MARANTZ SERVICE BULLETIN

model number 16	bulletin number 69-12/16-1	date 9-25-69
for serial numbers 16-1001	to	16-3000
subject MODIFICATION TO BE PERFORMED

Addendum for Model 16 (80 RMS 80)

Service Manual #199-1003,
dated September 17, 1969.

Figure 14. Marantz Model 16 Power Amplifier, Schematic Diagram.

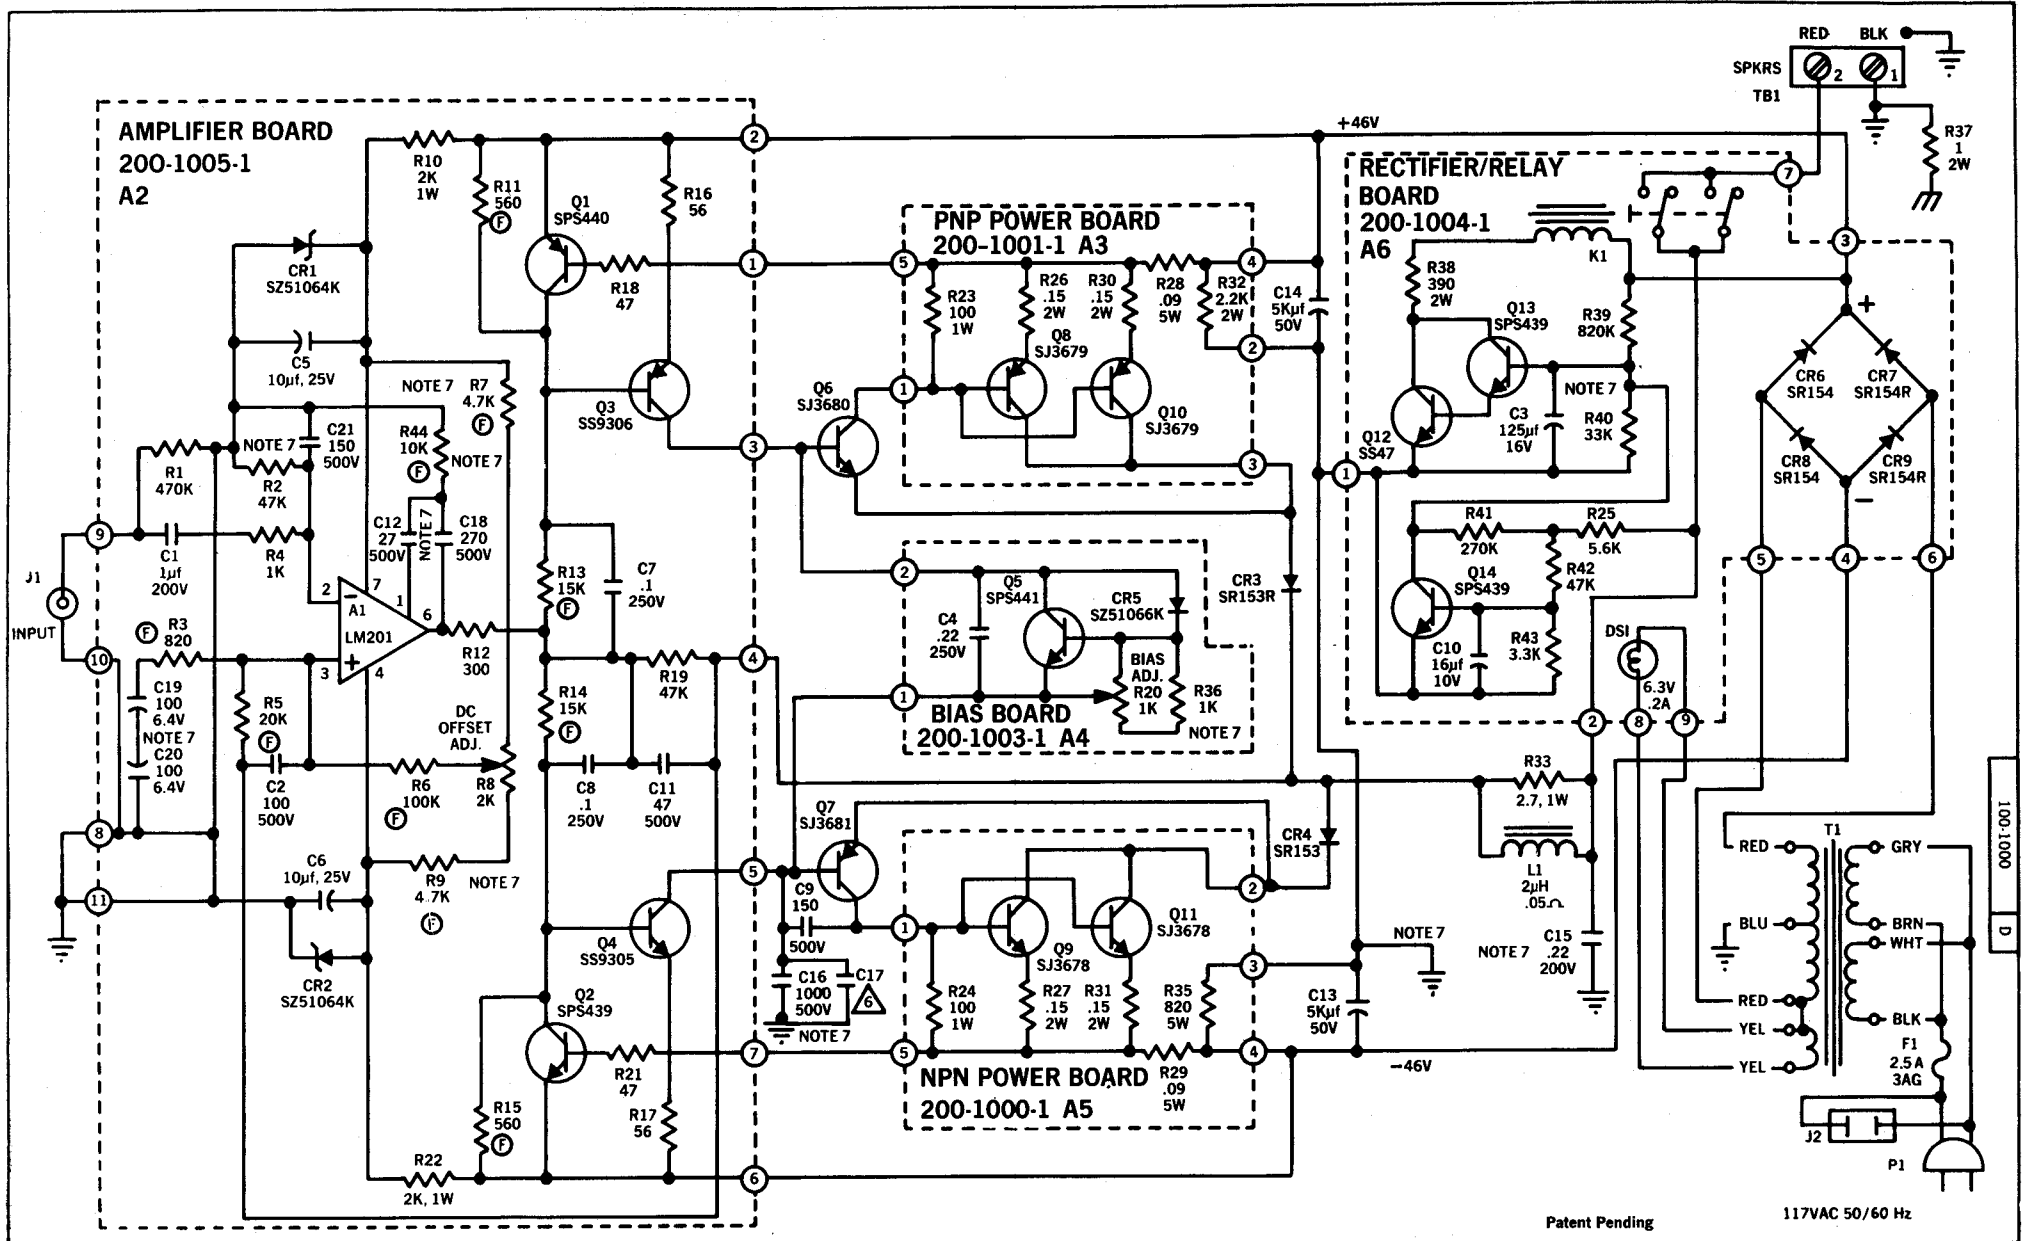
1. Insert change in following places: Figure 2, page 3; Figure 5, page 7; and Figure 14, page 21. Capacitor C8 was 0.1 μ f 250 VDC, is 0.022 μ f 100 VDC per E.C.N. 1097 and Marantz service bulletins 69-12/16-1 and 69-16/16-3.

6. On Figure 14, page 21, add capacitor C23, 300 pF, 500 V across R44, 10K.
7. On CHANGE RECORD add:
E.C.N. no. 1097 (item 1)
(Added: C23. Changed C8).
Dated: September 23, 1969.
Effectivity: S/N 1456, on.

8. Resistor R37 is 1.2 ohms. The callouts for this value should be corrected in the following places: Figure 1, page 2; Figure 14, page 21.
9. Disregard all sine-wave symbols on Figures 1, 2, 4 and 5. They are not always correct.
